CITY OF PORTLAND, MAINE **DEVELOPMENT REVIEW APPLICATION** ARTMENT PROCESSING FORM **DRC Copy**

Single Family Home Project Name/Description

555 - 555 Auburn St , Portland, Maine

RE: Final Site Inspection, (Project # 2006-0088), (CBL 382 A 023001)

DRAWING: 061700 4 OF 5 SHEET

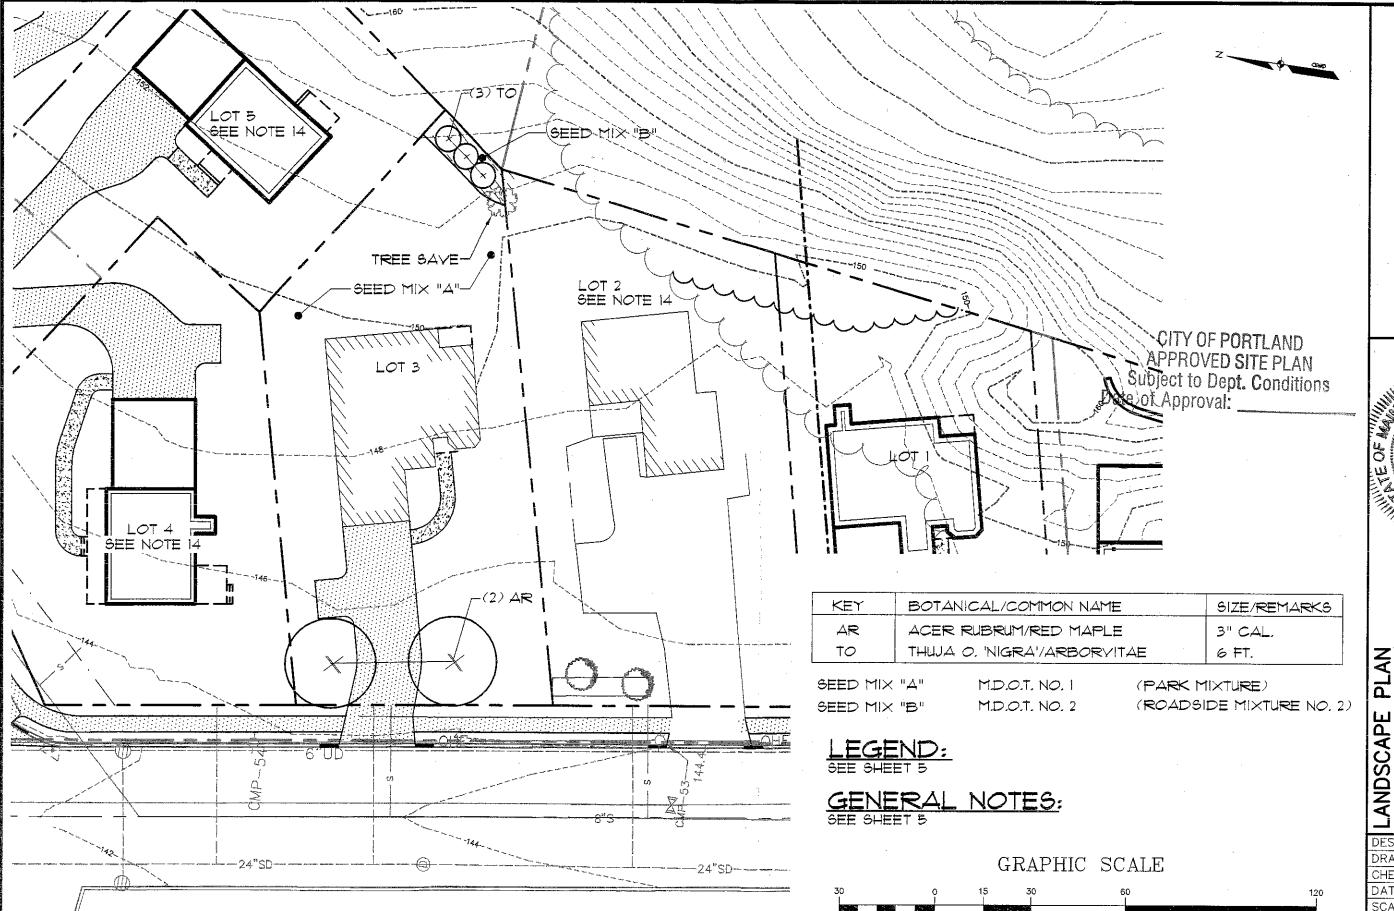
I looked at the site yesterday. The grading appears to be good, directed toward Auburn St. or to french drain. The site work is done except for seeding. All repairs to sidewalk, curb, street etc. appear good. The plans called for 2 trees in front to be 3", they are approx. 1" (too small). Keep in mind that the ground is ice and snow covered and should be inspected again in the spring. I spoke to the developer and voiced my concerns about the size of the trees. He said that if it was a problem, that he would replace them in the spring. He will also be seeding in the spring. I would recommend a temporary C of O pending seeding, tree replacement and final inspection in the spring. If you need any more info, I will be in the office tomorrow. Have a great day!

Two undersized street trees are installed, so the trees must be replaced with two trees of a minimum of three inch caliper meeting the City's Arboricultural standards prior to the final certificate of occupancy.

Two undersized street trees are installed, so the trees must be replaced with two trees of a minimum of three inch caliper meeting the City's Arboricultural standards prior to the final certificate of occupancy.
